Title: Village of Dobbs Ferry Planning Board , Engineer Comments design team responses

Project: The Masters School Innovation and Entrepreneurship Center

Date: June 17, 2021

TYPICAL CONCRETE SITE RETAINING WALL DETAIL
N.T.S.

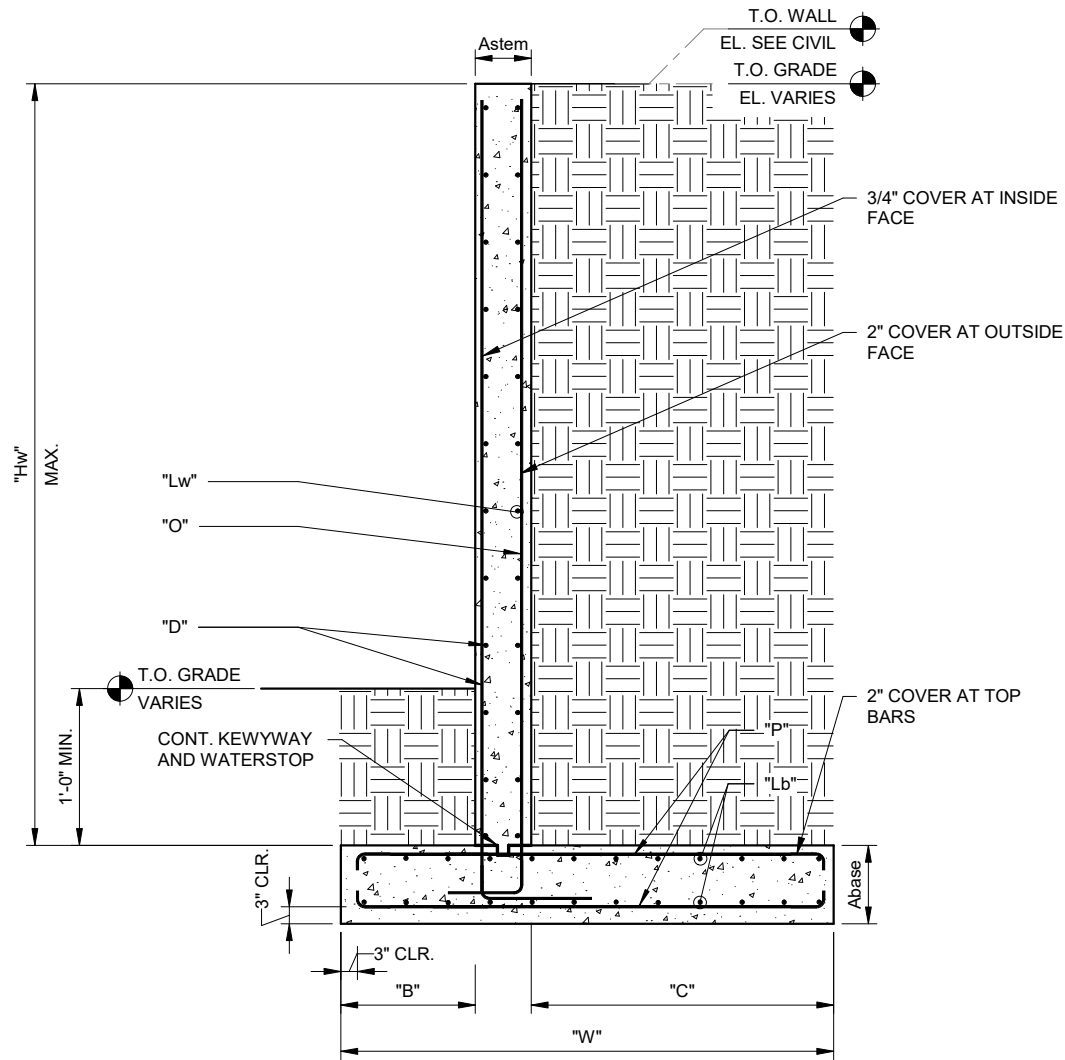
3. Sheet L-700 includes structures that were designed by a Landscape Architect. In accordance with NY EDN Law 7321, any drawings or calculations that include the design of structures must be signed and sealed by a NYS licensed architect or engineer.
 - *Team response: for any landscape retaining walls over 4'-0" in height, engineered signed and sealed drawings and calculations will be provided for the next Planning Board.*

Retaining wall detail is included on S501 and signed and sealed detail on S501SK, attached to these comments.
